**ATTACHMENT ii**  
Planning and Development Board Staff Report

**DATE:** May 11, 2017 **FILE:** 15-DPV-72a

**SUBJECT:** Sol Van Buren, LLC requests Design and Site Plan to amend a previously approved residential development (Sol Van Buren) located at 2000 Van Buren Street.

TREE TRANSPLANT AND REMOVAL PLAN

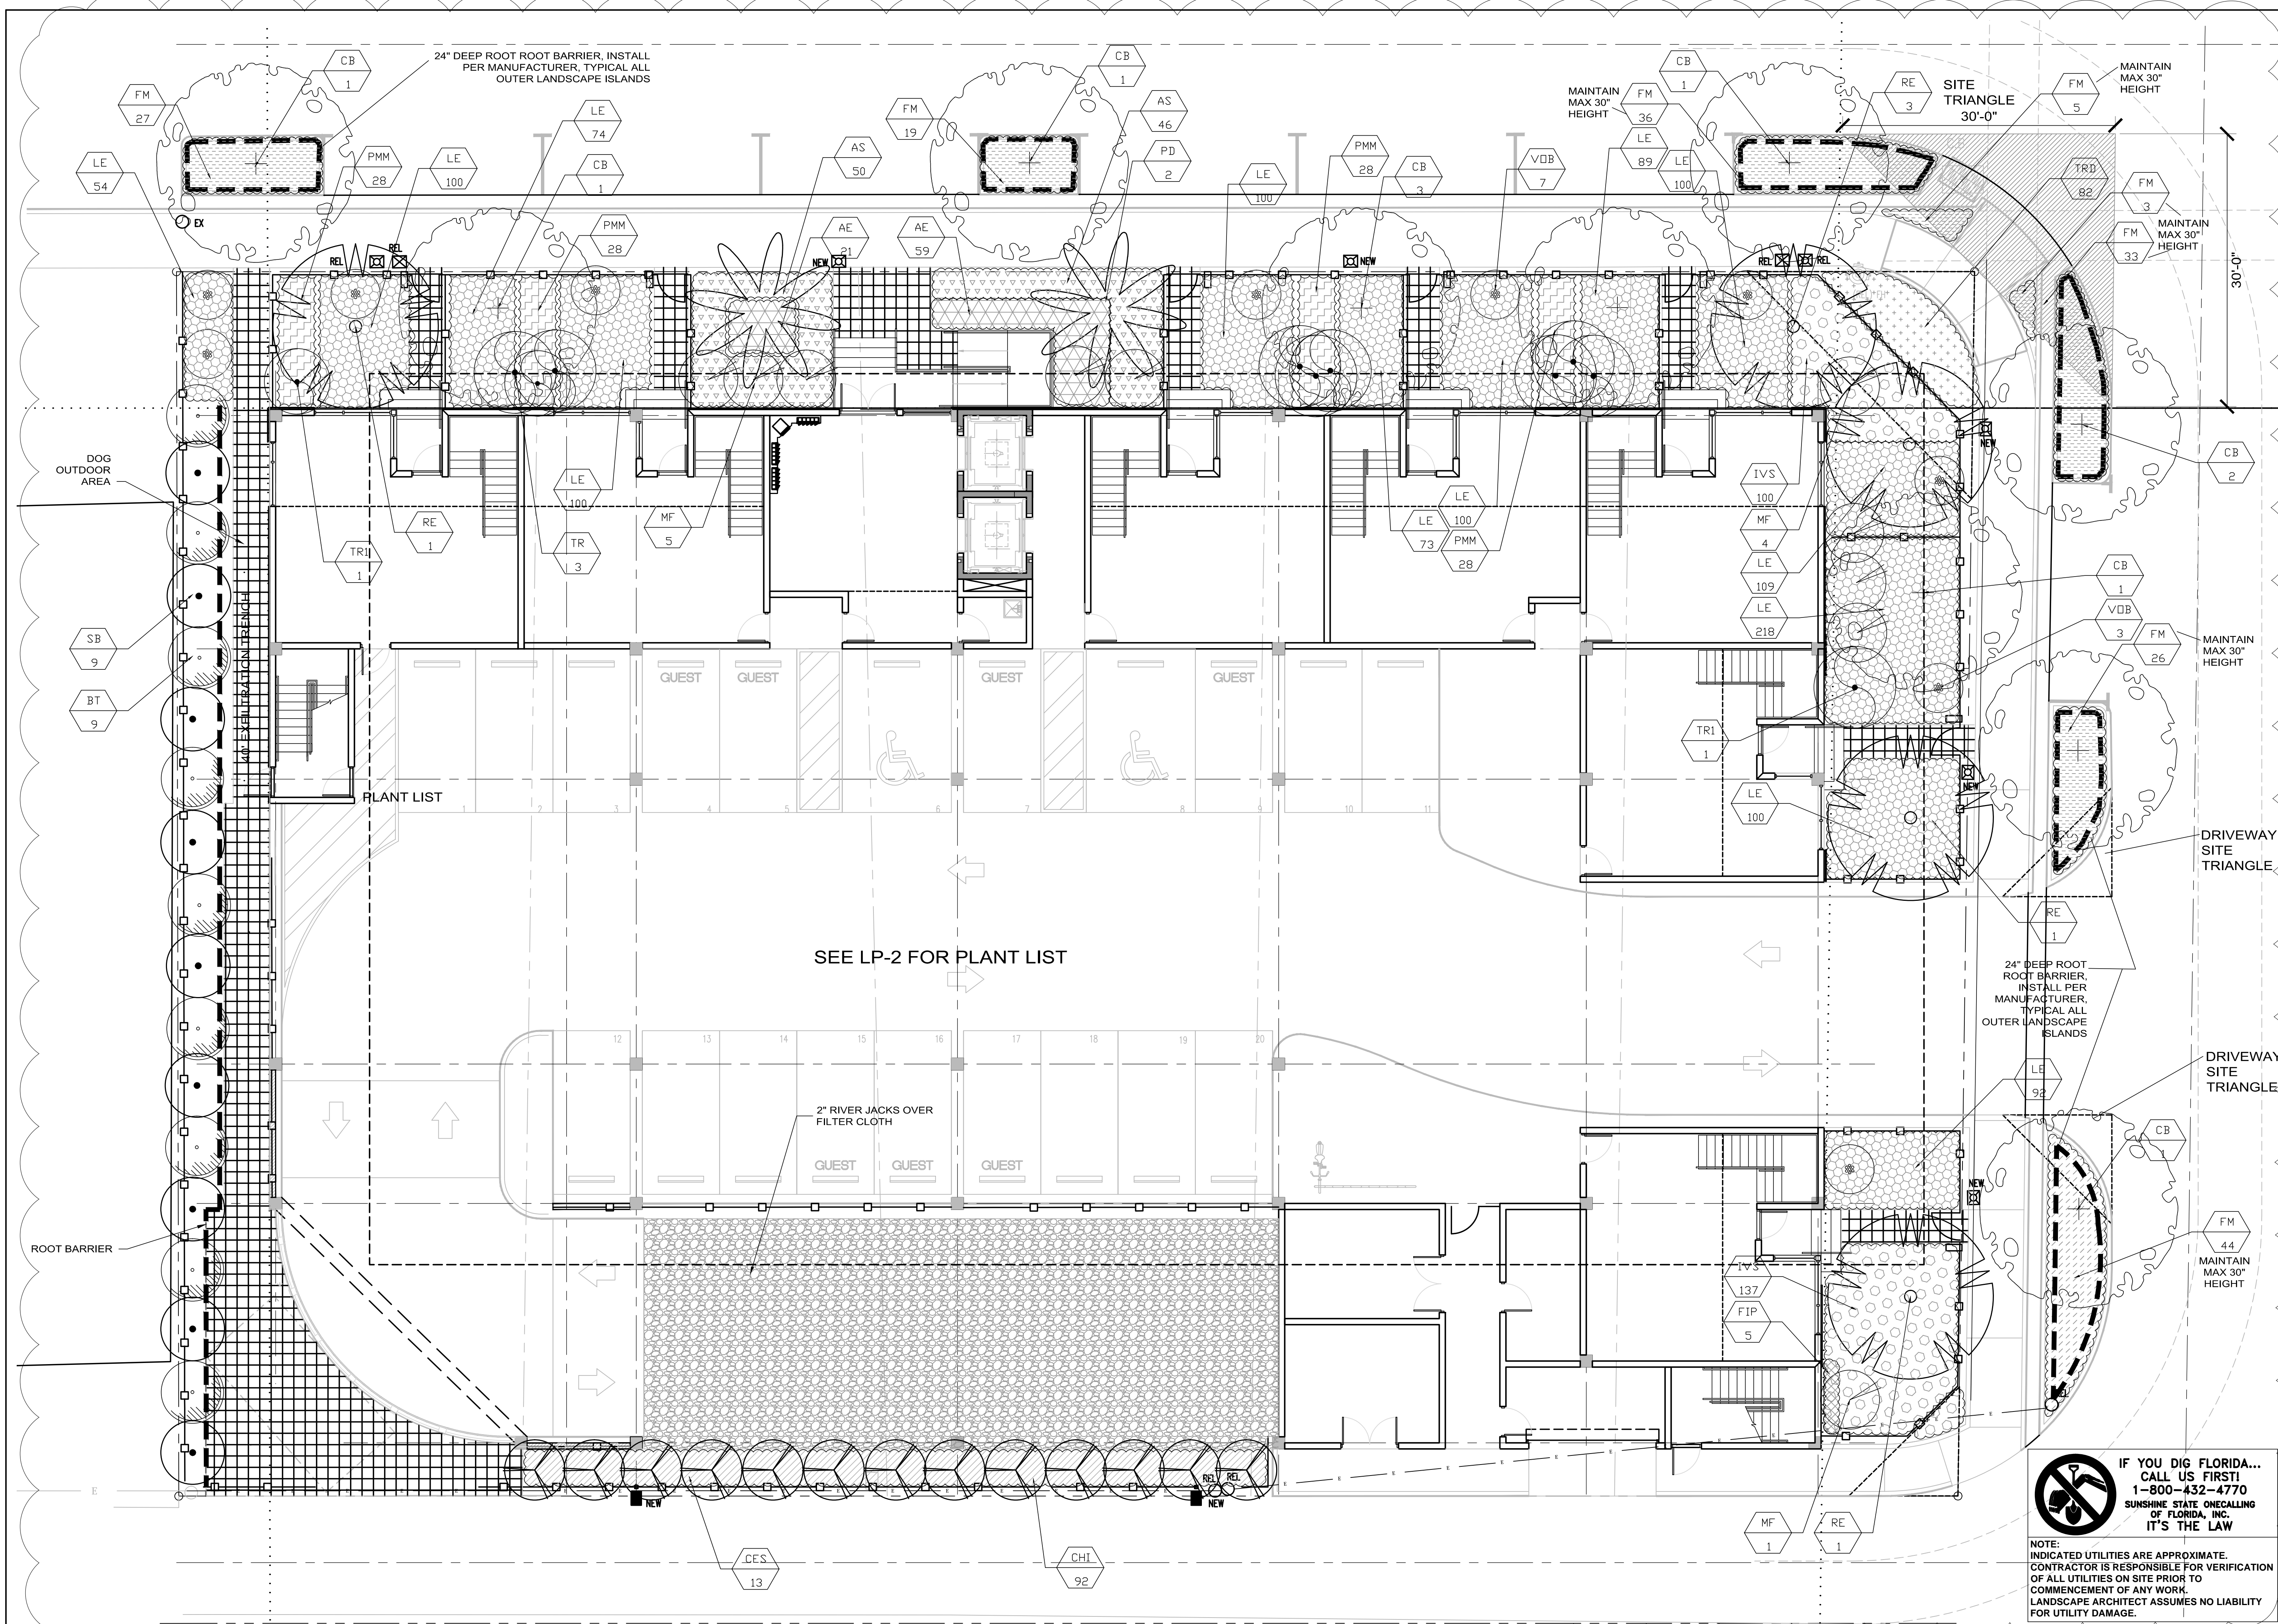
- Handwritten:* Will  
3-20-17
1. For any trees to be removed, provide mitigation requirements on tree disposition plan.  
3<sup>rd</sup> submittal: Calculations provided but are inaccurate.

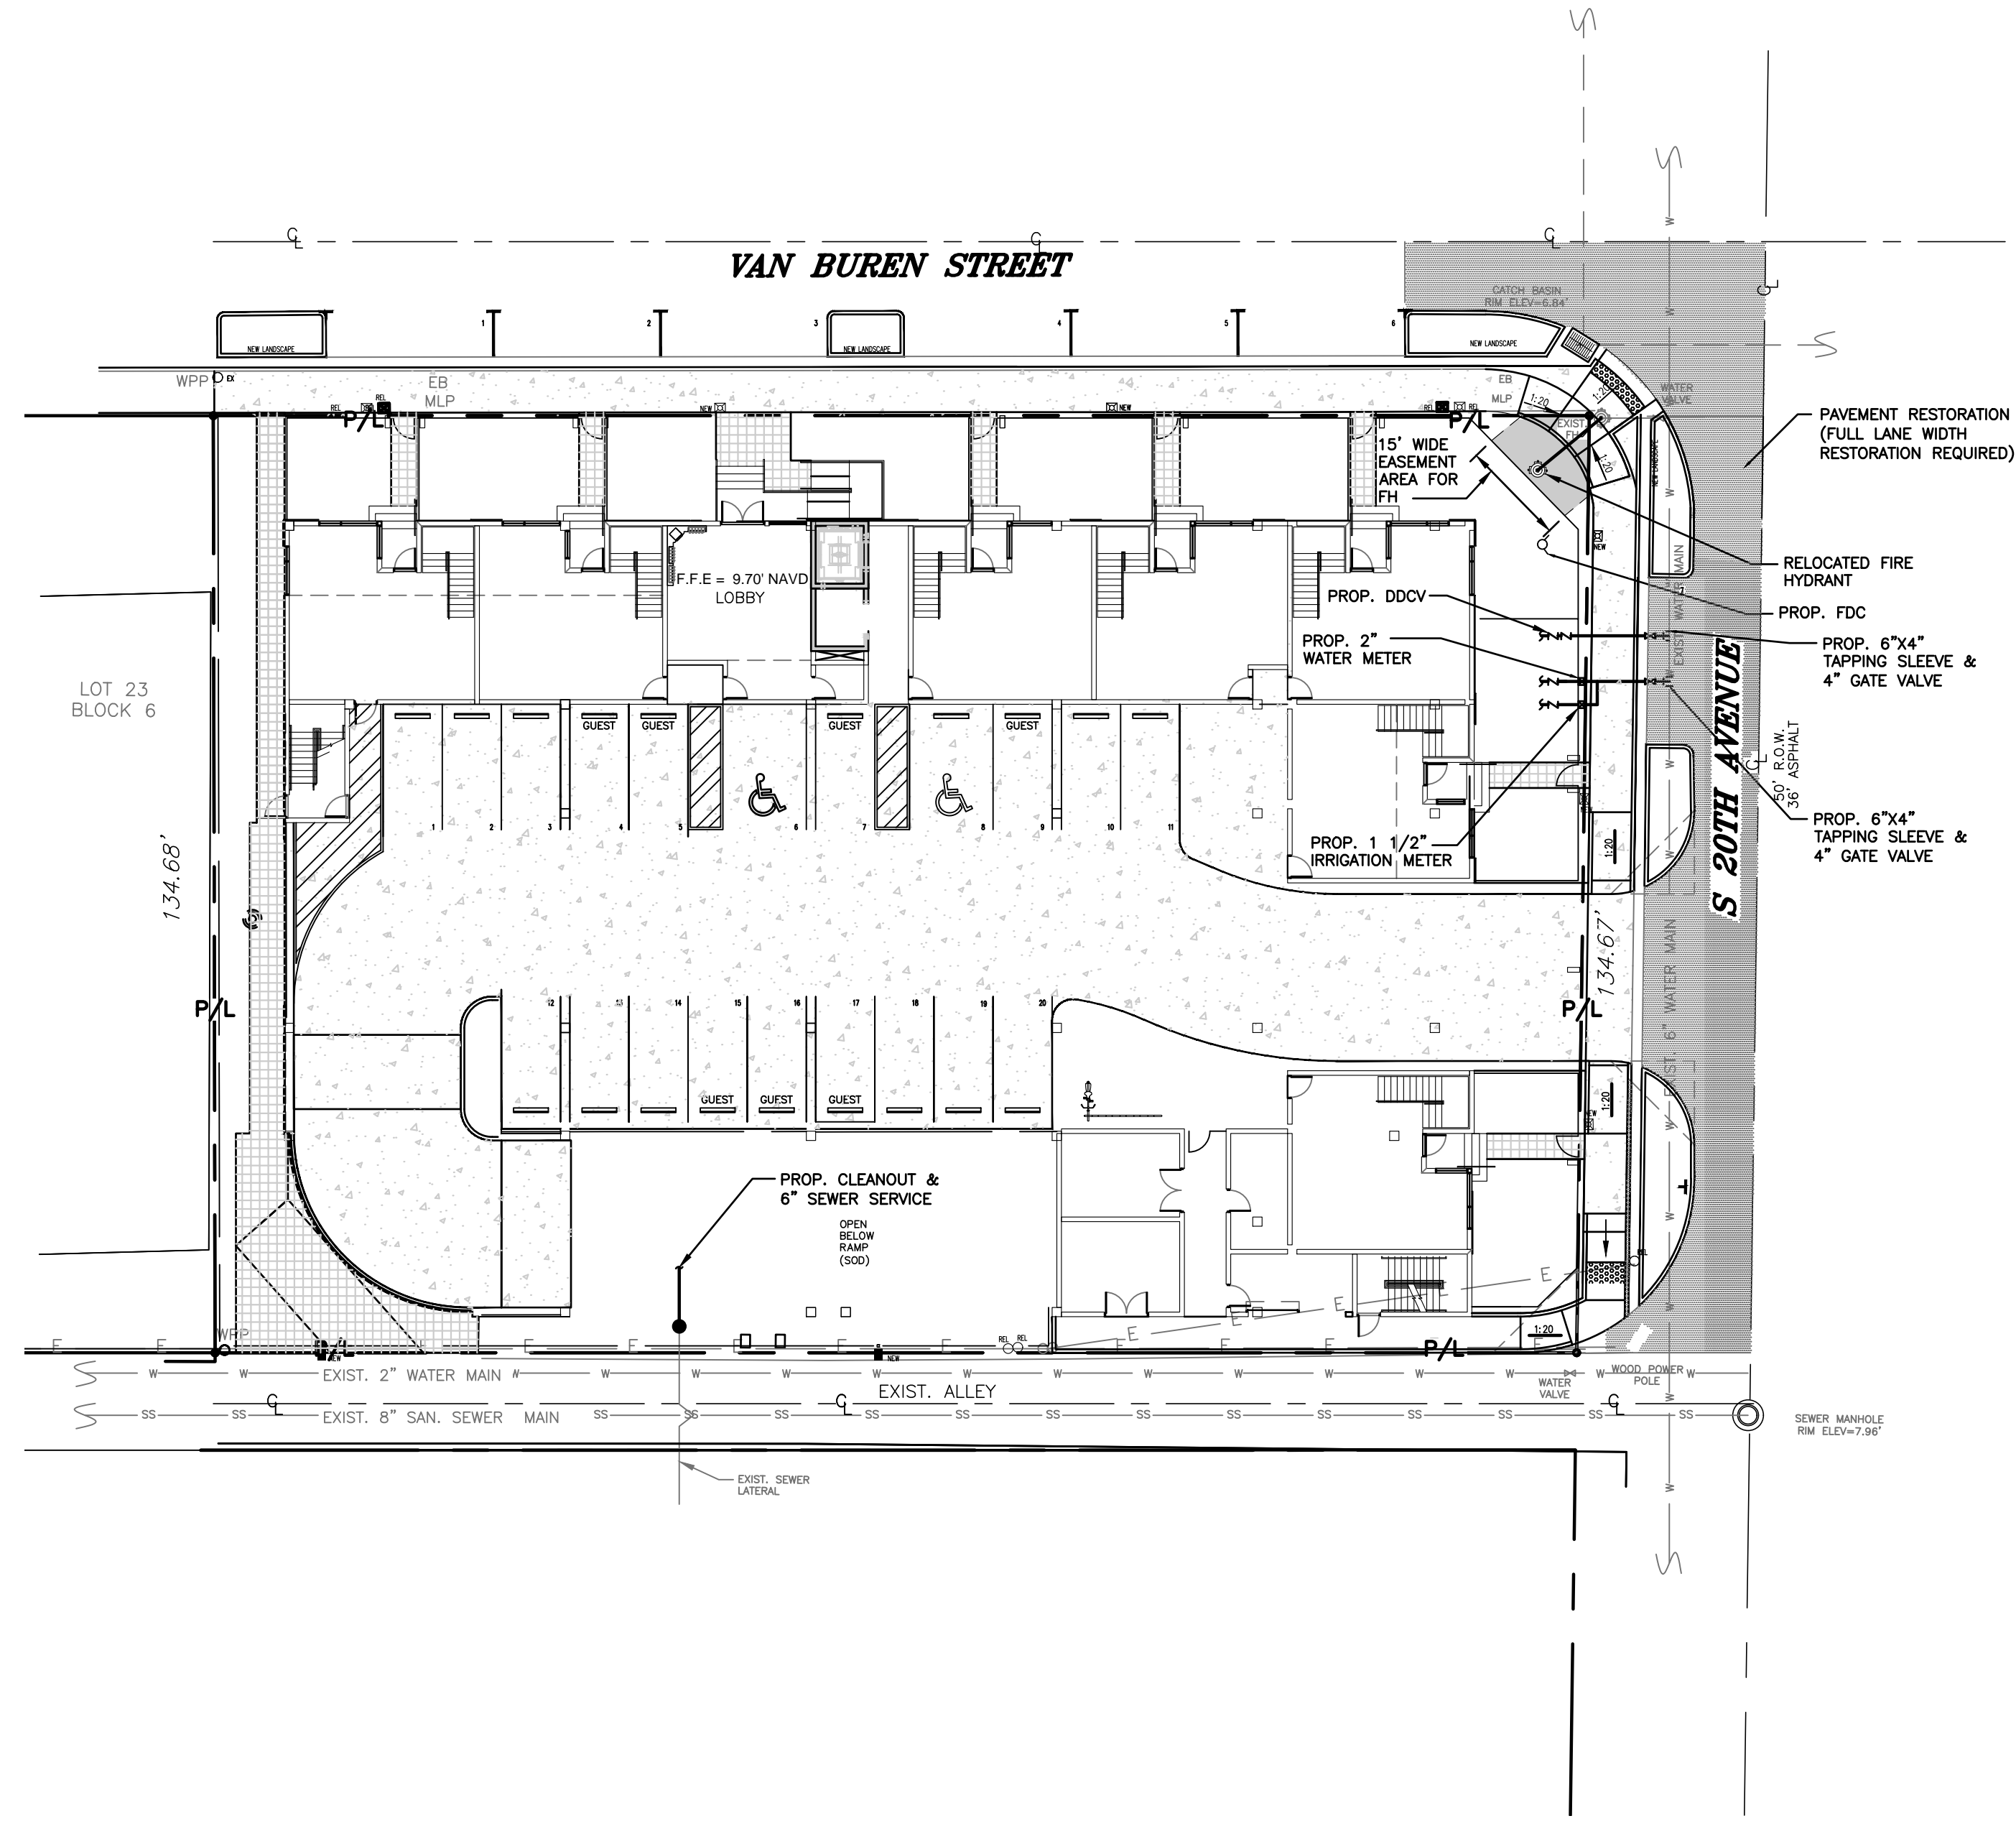
- W-2.*  
*3/20/17*
1. Plan sheet C-2 calls for an existing fire hydrant to be relocated. Show proposed location of the referenced fire hydrant. For onsite fire hydrants, a proposed 15' wide easement will be required.
  2. Callout taps as opposed to tees for the water and fire service connections along S 20th Ave. Fire line requires a tapping sleeve & valve and gate valve.
  3. Show water meters closer to property line, at back of sidewalk (on private side of property line).
